INVITATION FOR BIDS

Pav A Replace Chillers

ADDENDUM # 2

PAVILION A PROCESS CHILLER REPLACEMENT

HEET # M2.0

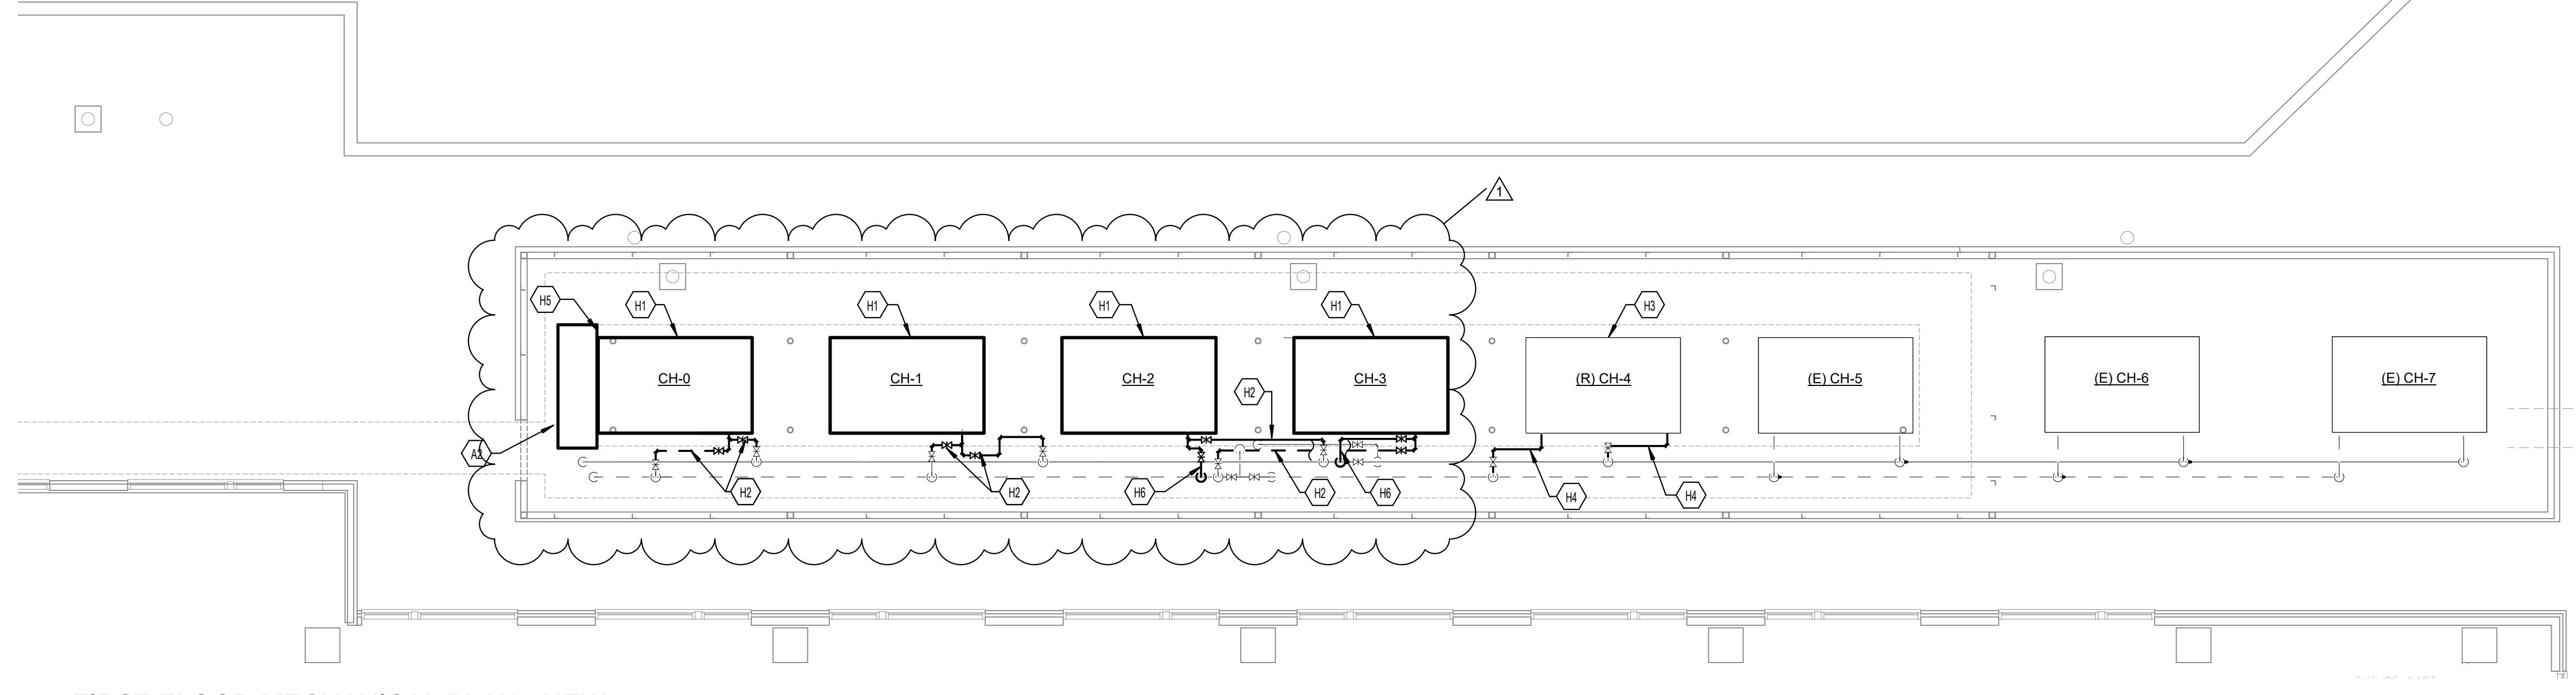
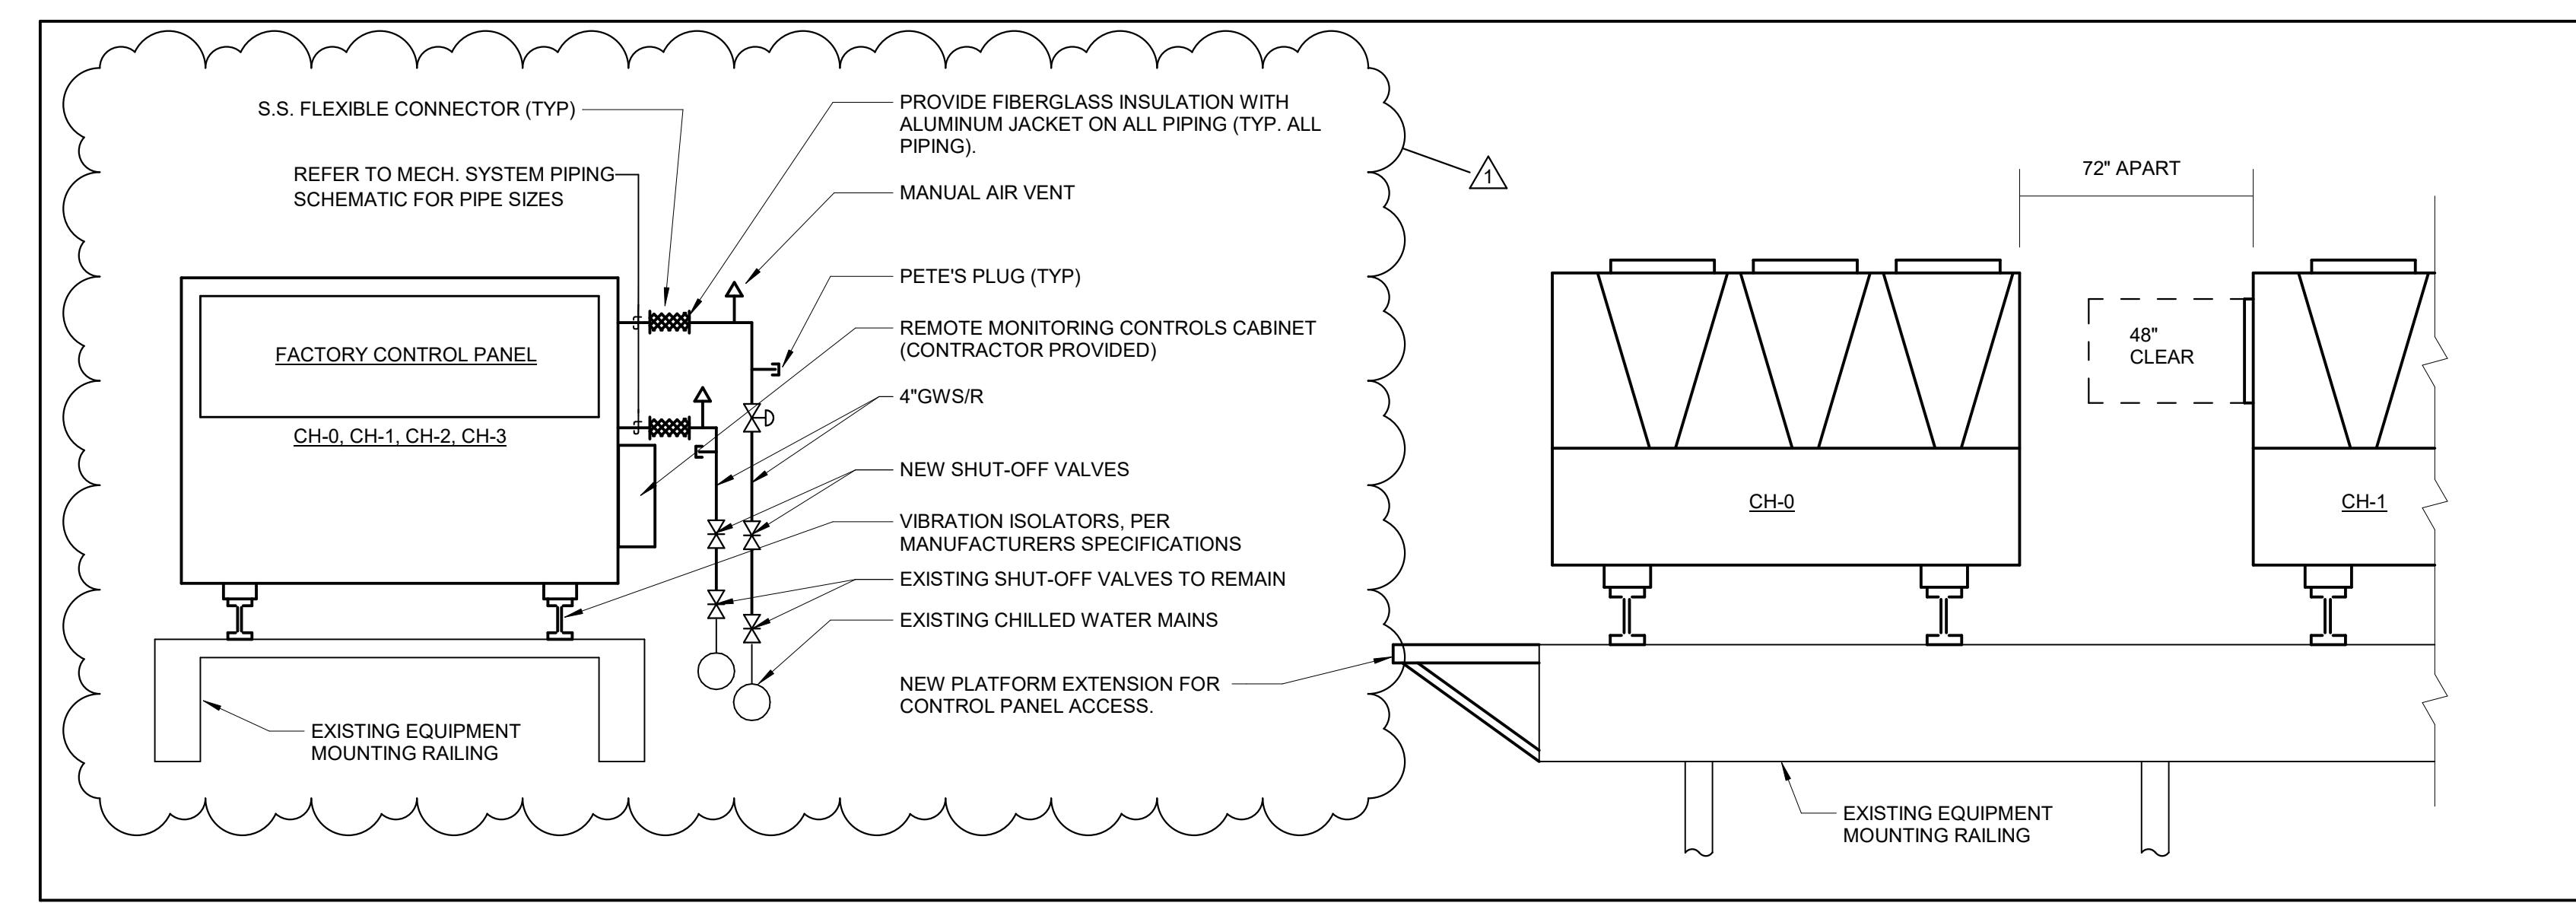
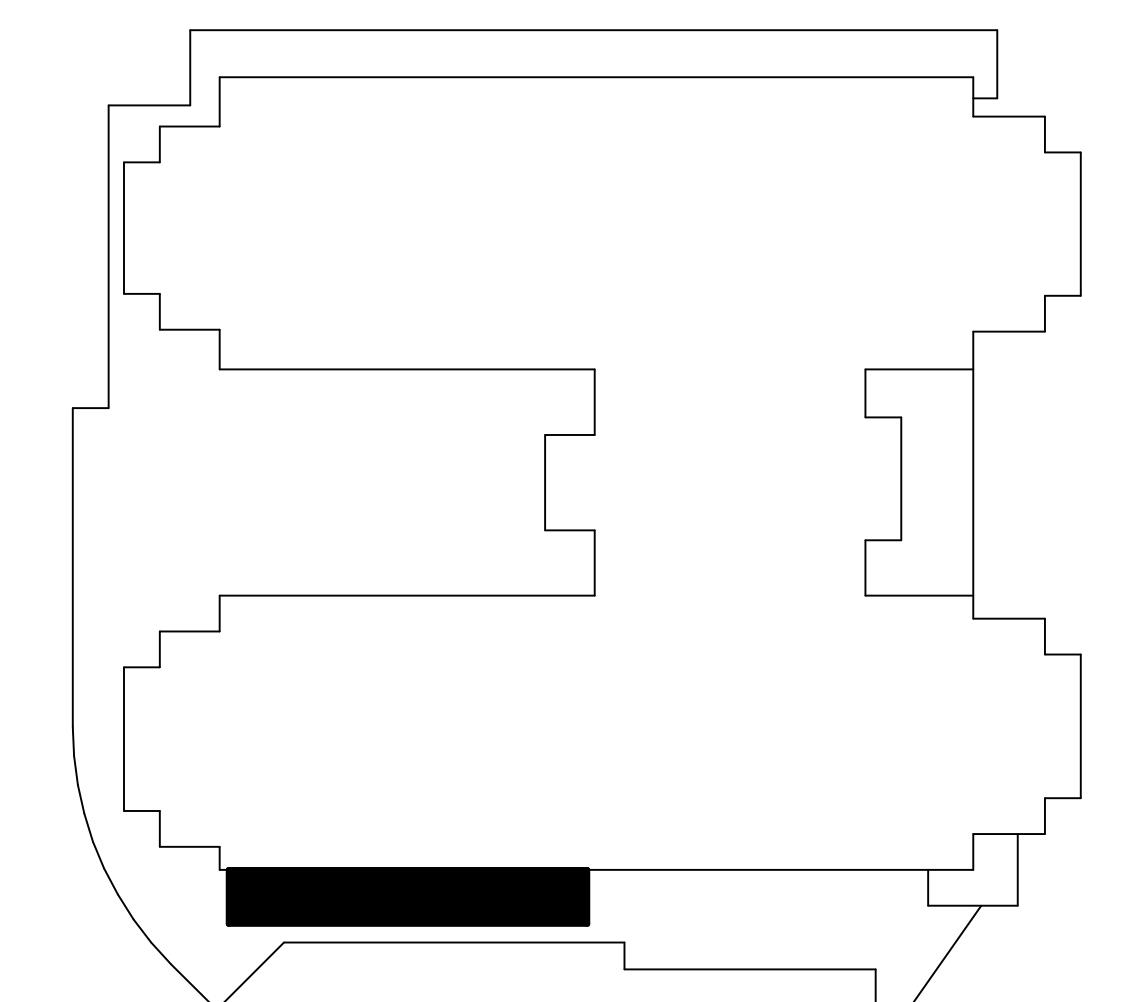
ITEM #2: Refer to attached M2.0

- A. Updated phasing plan**
- B. Updated installation details**
- C. Updated equipment specification**
- D. Updated piping connections and details**

1. THE PROJECT REPLACES THREE (3) EXISTING CHILLERS AND ADDS AN EIGHTH.
2. WHEN THIS CONTRACTOR IS AWARDED THE PROJECT, (E) CH-1, (E) CH-2 AND (E) CH-3 WILL PROVIDE COOLING TO PAV A KITCHEN FREEZER/COOLER, PAV A ELEVATOR MACHINE ROOM FANCOILS AND PAV A DIAGNOSTIC IMAGING EQUIPMENT. (E) CH-4, (E) CH-5, (E) CH-6 AND (E) CH-7 WILL PROVIDE COOLING TO HALF OF THE PAV A DATA CENTER. THESE GROUPS OF CHILLERS WILL BE SEPARATED AND OPERATE INDEPENDENTLY BY TWO MANUAL ISOLATION VALVES. REFER TO TAGGED NOTE MD6 FOR ADDITIONAL INFORMATION.

3. (E) CH-4 CAN BE RELOCATED WITHOUT REQUIRING A COOLING OUTAGE TO THE DATA CENTER. CONTRACTOR SHALL COORDINATE WITH OWNER ON SCHEDULE OF WORK AND ISOLATE CHILLER WITH BRANCH SHUT-OFF VALVES. COOLING DEMAND CAN BE MET WITH 3 REMAINING OPERATIONAL CHILLERS (E) CH-5, (E) CH-6 AND (E) CH-7.

4. ONCE (E) CH-4 HAS BEEN RELOCATED AND IS FUNCTIONAL, (E) CH-3 CAN BE DEMOLISHED. (E) CH-1 AND (E) CH-2 SHALL REMAIN OPERATIONAL.
5. CH-3 SHALL BE INSTALLED COMPLETE PRIOR TO SUBSEQUENT DEMOLITION AND INSTALLATION. DEMOLITION AND INSTALLATION OF EQUIPMENT SHALL BE PHASED SUCH THAT AT NO TIME WILL LESS THAN TWO (2) CHILLERS OF THE GROUP (E) CH-1, (E) CH-2 AND CH-3 BE OPERABLE.

6. NEW 4" BRANCH PIPES SHALL BE INSTALLED BY HOT TAP PROCESS TO CONNECT TO CH-3. DRAINING THE MAIN CHILLED WATER PIPES ARE NOT POSSIBLE. HOT TAP FOR EACH PIPE SHALL BE BEFORE THE SYSTEM SEPARATING ISOLATION VALVES.

7. CH-0, CH-1 AND CH-2 SHALL UTILIZE EXISTING EQUIPMENT BRANCHES. EXISTING BRANCH VALVES SHALL BE CLOSED TO ISOLATE THE EQUIPMENT AND COOLING PLANT SHALL REMAIN FUNCTIONAL AT ALL TIMES.

H6 PROVIDE NEW 4" HOT TAP OF EXISTING CHILLED WATER MAINS. HOT TAPS SHALL BE UPSTREAM OF SYSTEM ISOLATION VALVES FOR BOTH SUPPLY AND RETURN.

CCK#2671.0-1-25					
Question and Response Log					
Question Deadline					
#	Date	From	Question	Responder	Response
1	11/18/2024	HMC	What sizes are the existing main & branch lines?	CMTA	Refer to revised drawings included in addendum
2	11/18/2024	HMC	Will Chillers be removed and replaced all at once or separate days/lifts?	CMTA	Refer to phasing plan on drawings included in addendum
3	11/18/2024	HMC	Will we need to supply additional glycol for refill?	CMTA	Yes, the contractor is responsible for providing glycol for any refilling required.
4	11/18/2024	HMC	Can all work be performed during regular working hours or will we need include work for after hours?	UK FPM	Regular working hours
5	11/18/2024	HMC	Aside from the <i>Form of Proposal</i> & the <i>Bid Bond</i> , will any other documents need to be included on the day of the bid?	Purchasing	Any Signed Addendum need included with proposal.
6	11/19/2024	Finney	What size are the chilled water mains shown on Drawing M2.0?	CMTA	Refer to revised drawings included in addendum

7	11/19/2024	Finney	Can the chilled water mains shown on drawing m2.0 be shut off, isolated or drained to facilitate tie-ins without effecting normal operations?	CMTA	Refer to revised drawings included in addendum
8	11/19/2024	Finney	What size are the branch lines going to the new and relocated chillers?	CMTA	Refer to revised drawings included in addendum
9	11/19/2024	Finney	What is the budget for this project?	Purchasing	\$650,000
10	11/19/2024	Finney	What are the crane insurance requirements for the project?	UK FPM	See section 41.2.1 of the Special Conditions.
11	11/19/2024	Finney	Who is responsible for recovering/refilling glycol for chilled water?	CMTA	the contractor
12	11/19/2024	Finney	Who has the bond for the roof?	UK FPM	No roof work necessary. If any damage is done, contact UK FPM immediately.
13	11/20/2024	Lagco	Print M 2.00. Please provide the chilled water pipe sizes for the existing mains and the new piping serving the chillers.	CMTA	Refer to revised drawings included in addendum

i. Please provide a specification confirming the type and % of glycol required for this system.	CMTA	Refer to revised drawings included in addendum
17	11/21/2024	TJ Dyer	2. It is our understanding the existing mains cannot be shut down as they are "mission critical".	CMTA	Refer to phasing plan on drawings included in addendum

a. The demo drawing states "DEMOLISH PIPING CONNECTIONS FROM CHILLER BACK TO MAIN PIPING. PATCH AND REPAIR INSULATION TO MATCH EXISTING, PREPARE FOR NEW PIPING CONNECTIONS."	CMTA	Refer to revised drawings included in addendum

b. The new install drawings state "CONNECT NEW CHILLED WATER PIPING FROM NEW CHILLER TO EXISTING CHILLED WATER MAINS." This, along with the drawing diagrams imply we are to make new connections to the existing mains for each of the chillers (exception would be the relocated chiller).	CMTA	Refer to revised drawings included in addendum

c. Since the existing mains cannot be isolated, is the intention to blind flange the existing taps at the isolation valves and do hot taps for each of the new tap locations? Please confirm the intent.	CMTA	Refer to revised drawings included in addendum
18	11/21/2024	TJ Dyer	3. It is our understanding this work will need to be phased as not all chillers can be taken offline at one time.	CMTA	Refer to phasing plan on drawings included in addendum

a. How many chillers can be taken offline at one time?	CMTA	Refer to phasing plan on drawings included in addendum

19	11/21/2024	TJ Dyer	4. No line sizes are listed on the drawings. a. Please provide line sizes for existing mains and chiller connections.	CMTA	Refer to revised drawings included in addendum
20	11/21/2024	TJ Dyer	5. What is the intent for the chillers being removed? a. Are these going to be salvaged by UK, or do we need to remove refrigerant and dispose of these units.	CMTA	Chillers are to be demolished and properly disposed.
21	11/21/2024	TJ Dyer	6. Are there any heat tracing requirements for this work?	CMTA	no heat trace requirements
22	11/21/2024	TJ Dyer	7. Specification Section 20 13 00 PIPE, PIPE FITTINGS AND PIPE SUPPORT states: i. Hydronic Piping 2" and smaller to be black iron or soldered copper i. 2-1/2" and larger is to be welded sched 40 black iron. i. Option to utilize grooved on piping 2" and larger b. These do not meet the standard UK specifications of 5" and down is to be copper and 6" and up is to be STD weight Black Iron piping. c. Please confirm this specification is correct and to be followed for this work.	CMTA	Demolished chillers are to be properly disposed of by the contractor Branch piping shall be schedule 40 carbon steel with welded fittings
